**RESPONSE TO REQUEST FOR ADDITIONAL INFORMATION**

**US-APWR Design Certification**

**Docket No.52-021**

**RAI NO.:** NO. 709-5489 REVISION 2  
**SRP SECTION:** 03.07.01 – Seismic Design Parameters  
**APPLICATION SECTION:** 3.7.1  
**DATE OF RAI ISSUE:** 03/07/11

**Figure 1, Comparison of US-APWR CSDRS and Ground Motion from New Reactor Applications**

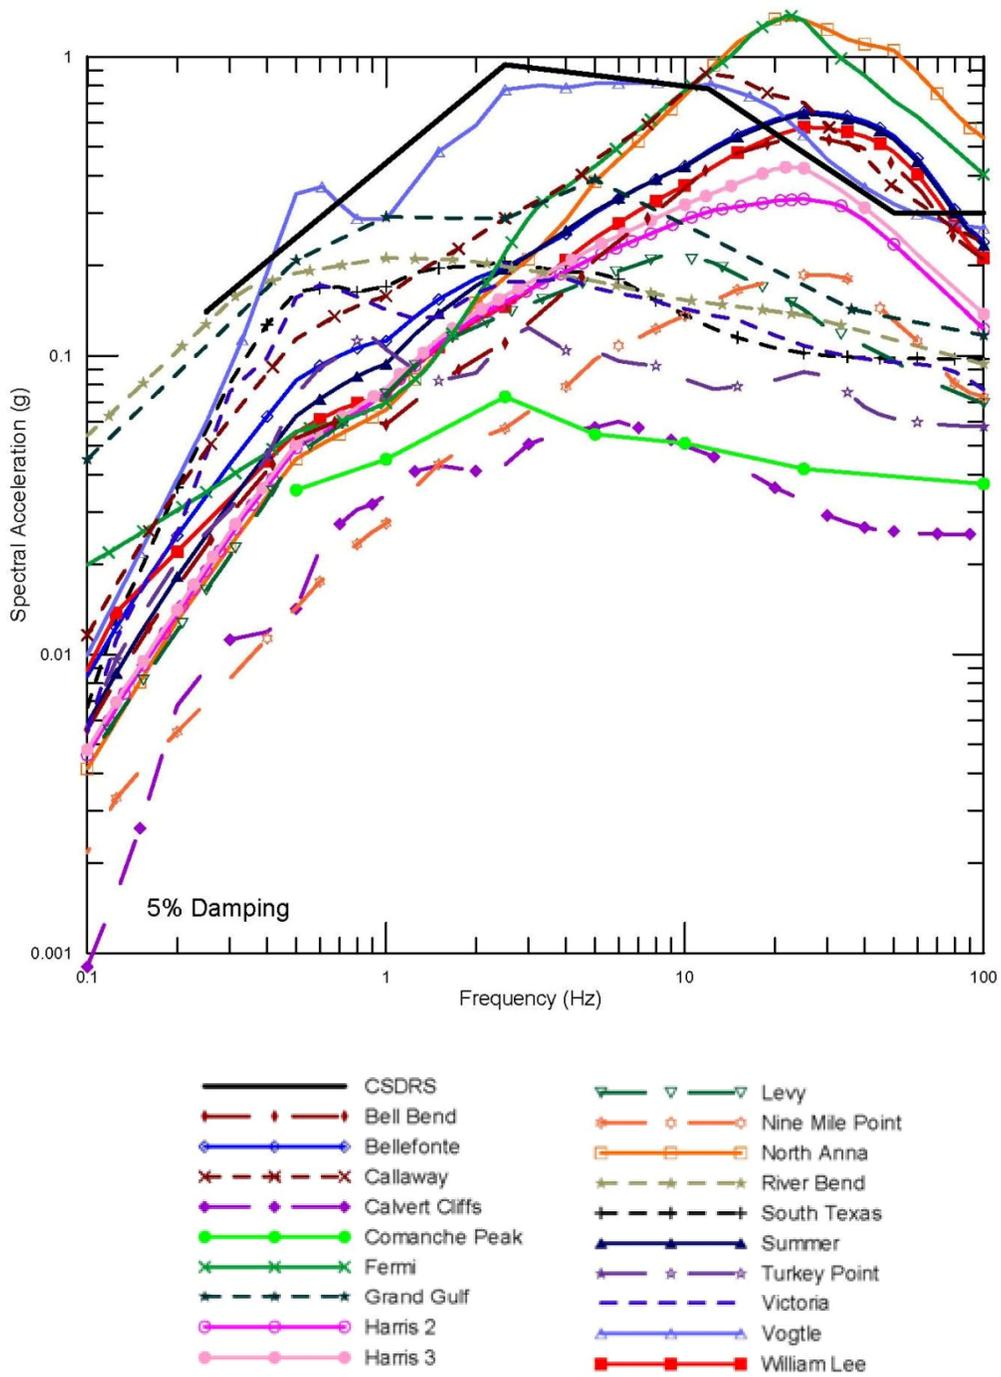
In its response dated November 11, 2010 to staff's RAI No. 643-4967, Revision 1, (Question NO. 03.07.1-16), the applicant made certain statements with regard to the applicability of the US-APWR certified standard design response spectra (CSDRS) to hard rock sites in Central and Eastern United States (CEUS), relative to response spectra characteristic in the high-frequency range. Specifically, the applicant stated the following:

1. It is recognized that for some of the hard rock sites in Central and Eastern United States (CEUS), the US-APWR CSDRS does not envelope the response spectra characteristic in the high-frequency range.
2. CSDRS are expected to envelope many sites in the central and eastern United States in order to maximize the applicability of the US-APWR standard plant design; however it is anticipated that there are some site-specific instances, particularly on hard rock sites in high seismic areas, where high-frequency exceedances of the CSDRS may occur.

In order to determine whether the requested US-APWR standard design is usable for a multiple number of units or at a multiple number of sites in the United States without reopening or repeating the staff's review, the staff requests that MHI provide quantitative information and details of specific analyses and data developed to support its response to RAI No. 643-4967, Revision 1, (Question NO. 03.07.1-16), dated November 11, 2010, particularly regarding the two statements noted above. The staff also requests that the applicant discuss whether the analysis of the site specific variation for the hard rock sites, where the US-APWR CSDRS does and does not envelope the response spectra characteristic in the high-frequency range, will lead to site-specific variations in the plant designs among plants that reference the US-APWR design. The applicant should also discuss the extent of such variations, as appropriate.

Figure 1 provided in this response is a comparison of the US-APWR CSDRS with the publicly available ground motion for new plant applications. The graph reflects that of the 19 ground motion curves, eleven curves are bounded by the CSDRS in the high-frequency range. The ground motion for these sites therefore reflects US-APWR compliance with the definition of *Standard Design* in 10 CFR Part 52, whereby the CSDRS “is usable for a multiple number of units or at a multiple number of sites without reopening or repeating the review.” Further, DCD Section 3.7.1.1 requires the COL Applicant to perform site-specific seismic analyses [COL 3.7(22)]. The site-specific soil structure interaction (SSI) analyses may consider seismic wave

When the site-specific ground motion for natural frequencies above 10 Hz are determined to exceed the CSDRS (see Figure 1), the design of standard plant structures is not expected to change since the dominant SSI frequencies for the standard plant structures are less than 10 Hz (refer to Section 03.4.1.1 of Technical Report MUAP-10006, Rev. 3 for a summary of first-peak SSI frequencies for the R/B complex). This conclusion is made since the seismic design for these hard rock sites are bounded by the CSDRS values for natural frequencies less than 10 Hz (the low-frequency outlier is a soft soil site). Similarly, there is no impact to the core internals and fuel rods because the dominant frequencies are also less than 10 Hz. Therefore, the seismic design for the standard plant structures, the core internals and fuel rods are not affected for hard rock sites in CEUS.
